Well Name: BURCH KEELY UNIT	Well Location: T17S / R29E / SEC 26 / NESW /	County or Parish/State: EDDY / NM
Well Number: 174	Type of Well: OIL WELL	Allottee or Tribe Name:
Lease Number: NMLC028784C	Unit or CA Name: BURCH KEELY UNIT	Unit or CA Number: NMNM88525X
US Well Number: 3001503115	Well Status: Producing Oil Well	Operator: SPUR ENERGY PARTNERS LLC

Notice of Intent

Type of Submission: Notice of Intent Type of Action: Plug and Abandonment

BKU 174 P&A Procedure

Sundry ID 2725510

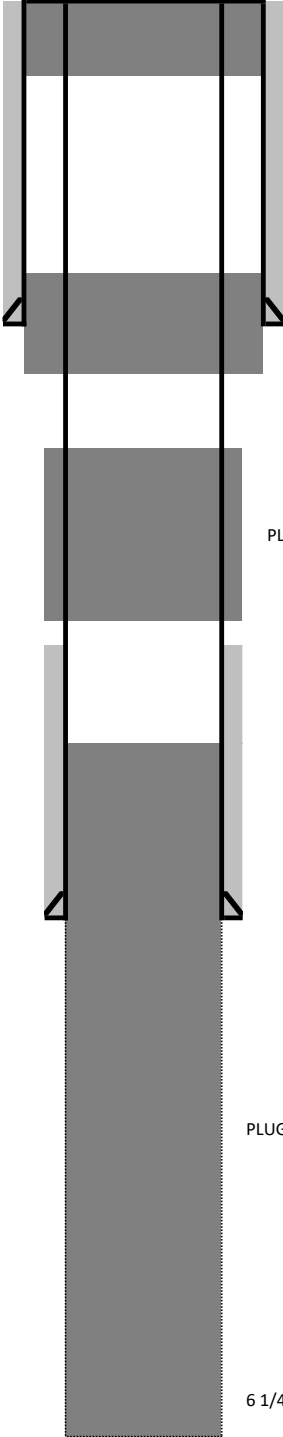
PLUG #4: P&S 35 SX CLASS C CMT @ 100' - 0'

PLUG #3: P&S 45 SX CLASS C CMT @ 415' - 285'
WOC, Tag and verify

PLUG #2: P&S 120 SX CLASS C CMT @ 940' - 700'
WOC, Tag and Verify. TOC
unidentified. If P&S
unsuccessful, CBL will be
needed to identify TOC

PLUG #1: SPOT 165 SX CLASS C CMT @ 3,272' - 2,625'
Leak test first barrier: 500psi, 30mins. If there are
casing leaks, identify and set plugs across. If
leaking at plug, set CIBP above and re-test

Plug Type	Top	Bottom	Length	Tag	Sacks	Notes
Surface Plug	0.00	100.00	100.00	Verify circulated to surface	35.00	Perf and sqz
Top of Salt @ 335	281.65	385.00	103.35	WOC and Tag	45.00	Same as below
Shoe Plug	312.34	416.00	103.66	WOC and Tag	45.00	Perf and sqz
Base of Salt @ 760	702.40	810.00	107.60	WOC and Tag	120.00	Same as below
Yates @ 889	830.11	939.00	108.89	WOC and Tag	120.00	Perf and sqz
Shoe Plug	2681.41	3272.00	590.59	WOC and Tag	165.00	Spot from TD to 2625'. Tag and verify. Leak test 500psi, 30mins

No more than 2000' is to be allowed between plugs in open hole, and no more than 3000' between plugs in cased hole.
